## ORIGINATION FORM

Proposed Revisions to a Standard Plans Index  
(Please provide all information — Incomplete forms will be returned)

Index Number: 639-002

Index Title: Electric Power Service

UNDERGROUND PEDESTAL  
MOUNTED METER  
FIGURE F

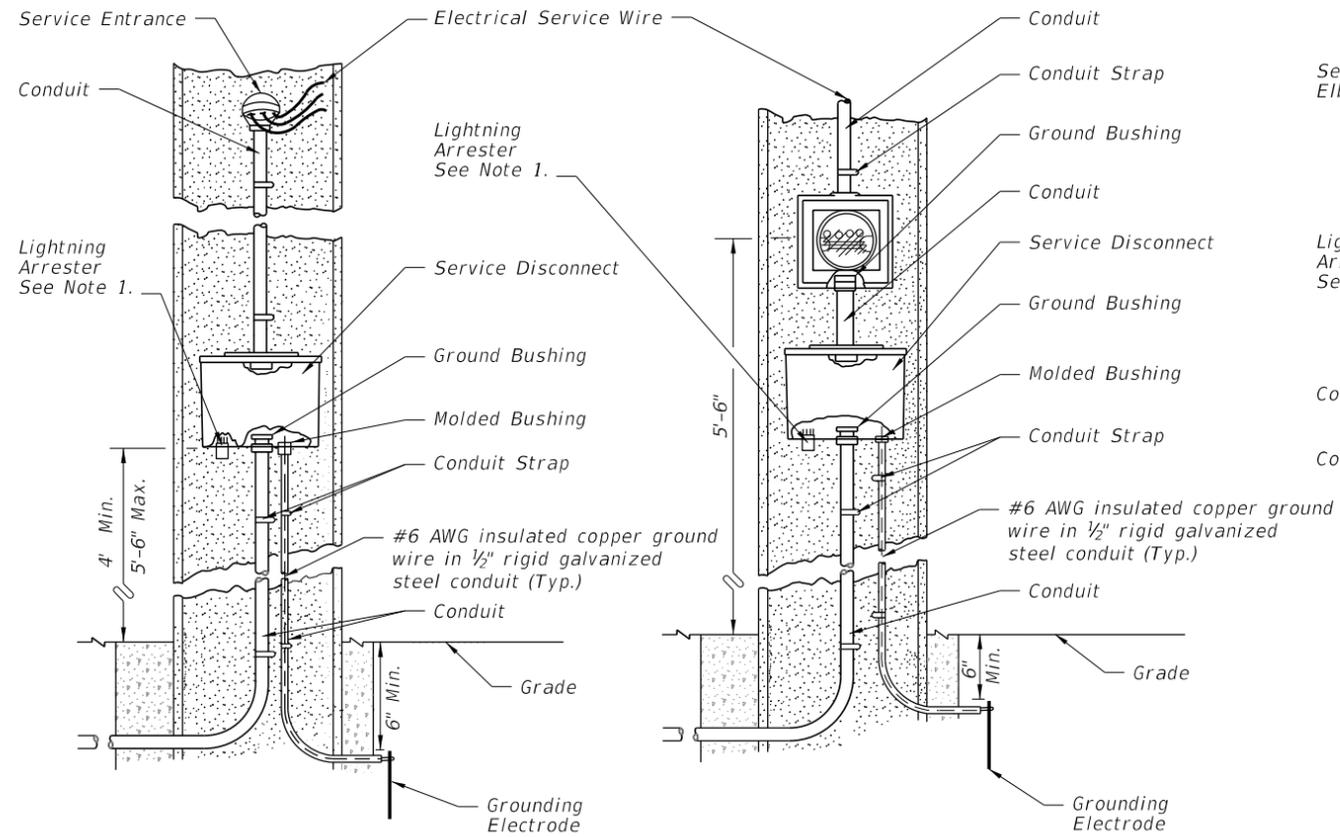
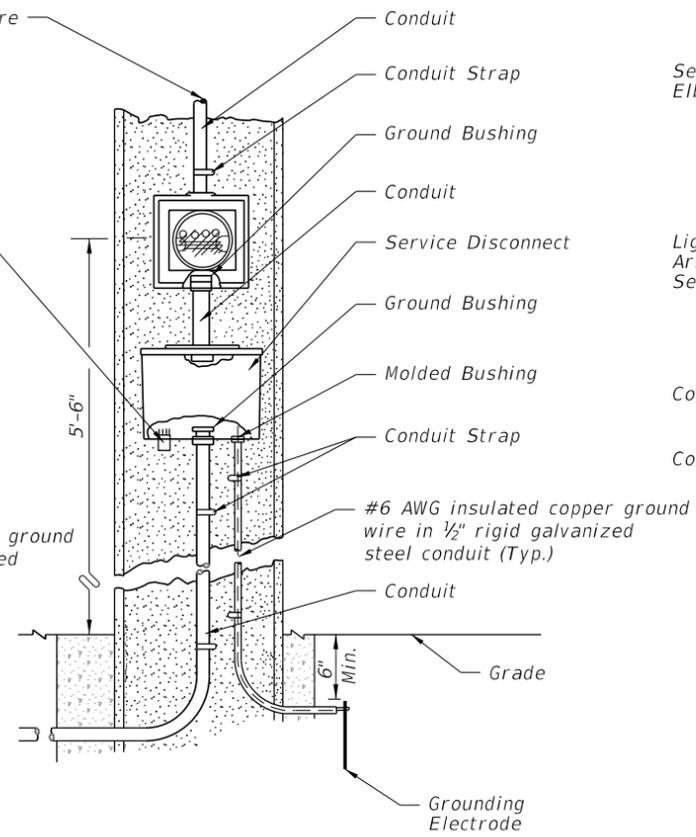
Added new figure for underground pedestal mounted meter.

Underground pedestal mounted meters have become more prevalent for new power services.

ADDED: New Detail
